Planning Commission Study Session

SUBJECT: DR19-63, A/C DOCTORS

DR19-63, A/C Doctors: Site plan, landscaping, grading and drainage, elevations, floor plans, lighting, colors and materials for approximately 1.17 acres, generally located at the northeast corner of Horne Street and Melody Avenue, and zoned Light Industrial (LI).

DR19-63 A/C Doctors Attachment 5: Building Elevations September 4, 2019

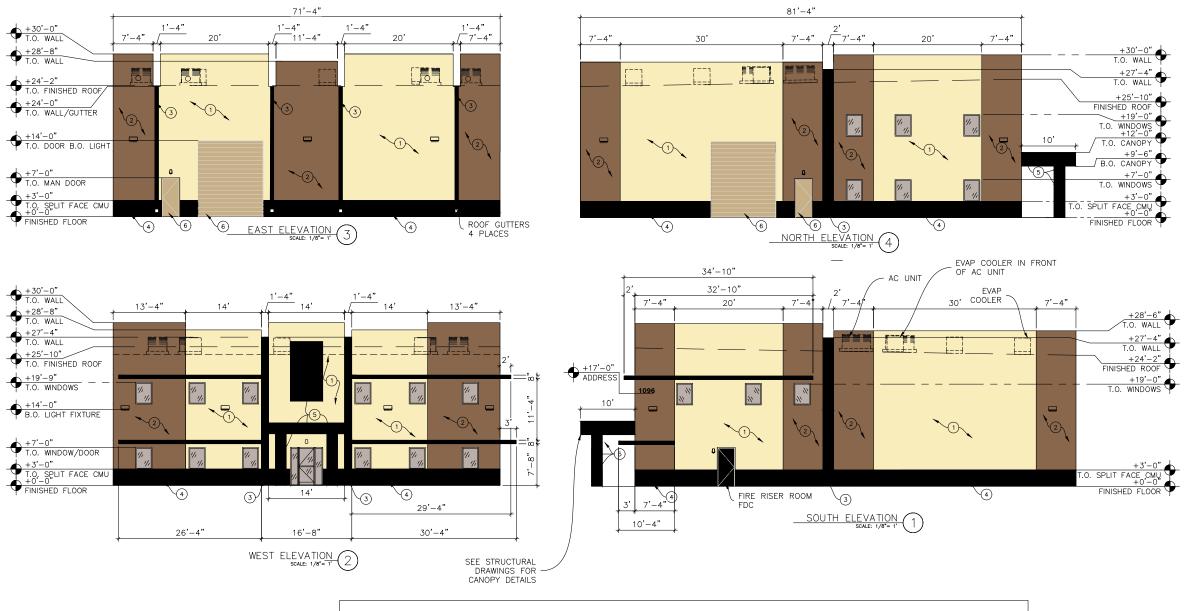
During review, staff has expressed concern over the lack of horizontal movement, long blank walls with no articulation, design of the main entry, window variation, window canopy design/placement, similarity of paint colors and lack of design consistency of other buildings in the immediate area. Staff is suggesting that additional visual interest be provided on all four elevations to include additional horizontal movement or shadow lines, color variation and other façade treatments. We are also suggesting that the design of the main entryway be enhanced, making it more of a focal point facing the public right of way.
